HISTORIC DISTRICT COMMISSION NOTICE OF DENIAL

Application Number: HDC2025-00589

APPLICANT & PROPERTY INFORMATION			
NAME: City of Detroit - General Services Department		COMPANY NAME: City of Detroit	
ADDRESS: 115 Erskine	CITY: Detroit	STATE: MI	ZIP: 48201
PROJECT ADDRESS: 2585 - 2603 W. Grand Blvd.			
HISTORIC DISTRICT: West Grand Boulevard African American Arts and Business Historic District			
SCOPE: Expand, alter and rehabilitate park

MARTIN LUTHER KING JR. MEMORIAL PARK (2589 W GRAND BLVD)

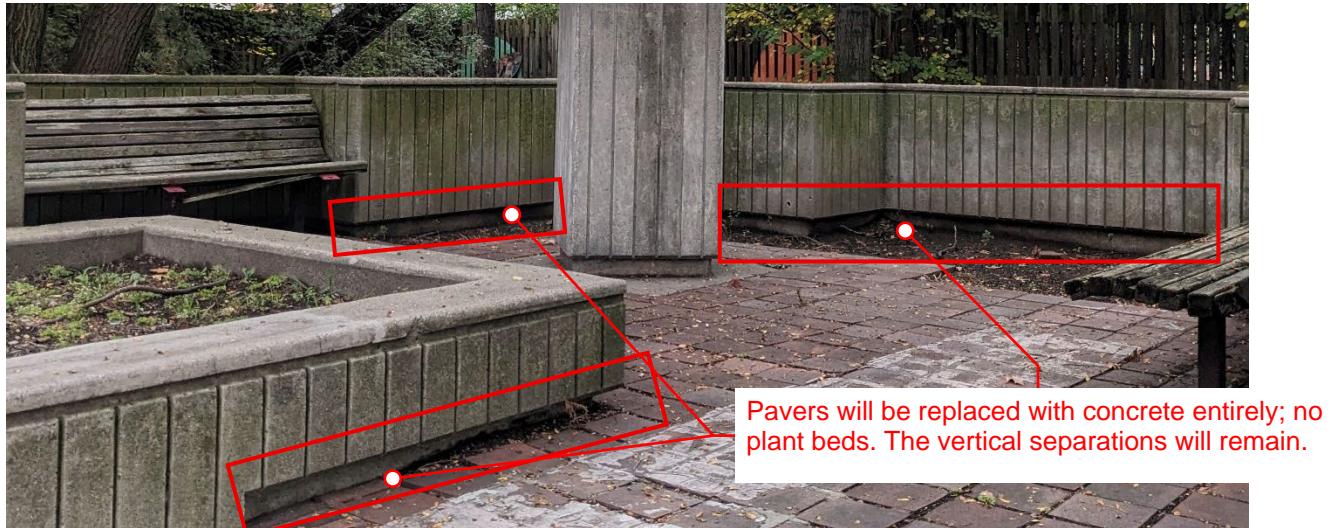
At the bust, will the platform retain its footprint once the brick pavers are replaced with concrete? There is currently a separation between the vertical concrete elements, and the floor surface, giving a sort of floating illusion. Can you confirm that this feature will remain?

I saw that you highlighted the areas with brick edging as proposed greenspace. Does this imply the brick will be surrounded by grass? How will this be maintained over time?

Brick edging and planting bed footprints to remain. Planting beds will have TBD planting material most likely a ground-cover. Green spaces = both lawn and plant bed areas.

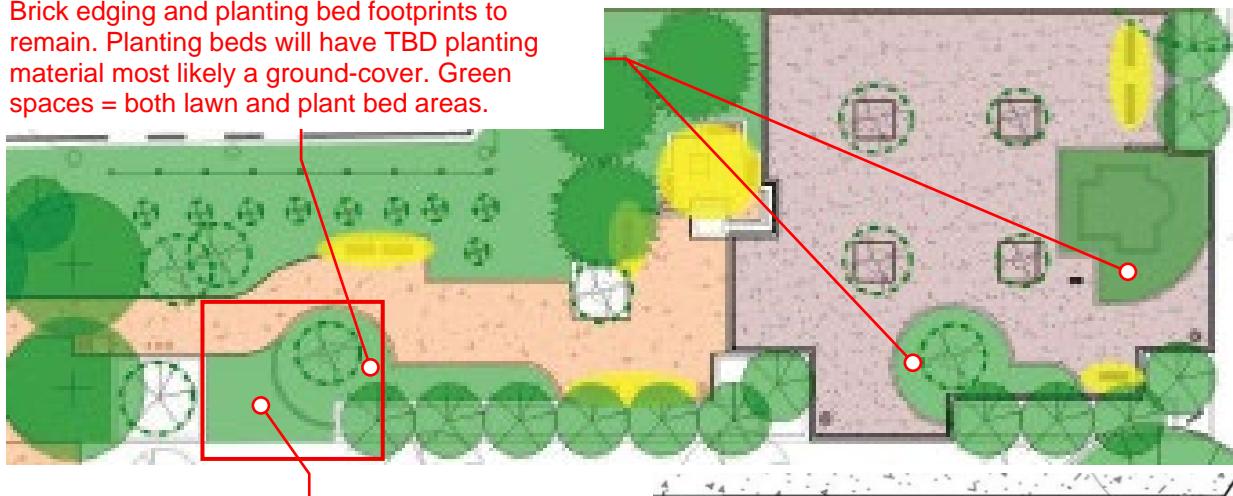
What do these lines imply? Please specify the material. 1' wide brushed concrete edge

Please reconfirm material designated for the main ground surface, as well as the material for the continued pathway: **Plaza area is a compacted crushed limestone surface and oth**

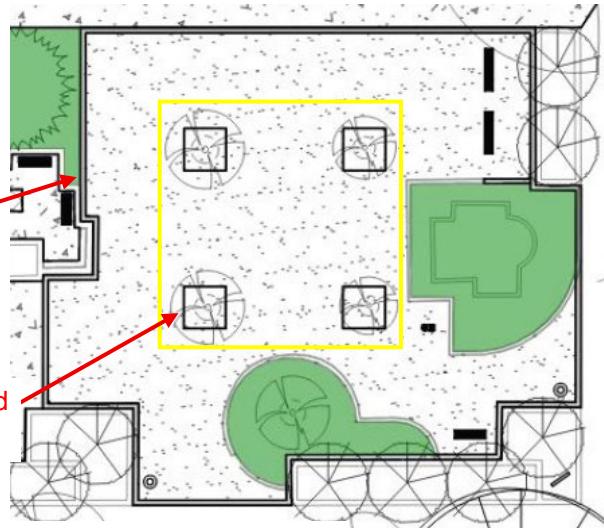
Please confirm materiality of all borders, including these tree openings

The lines bordering the trees are a drawing error; the plaza will be a compacted crushed limestone surface bordered by brushed concrete edge as specified in package and remaining surfaces in the park will be concrete
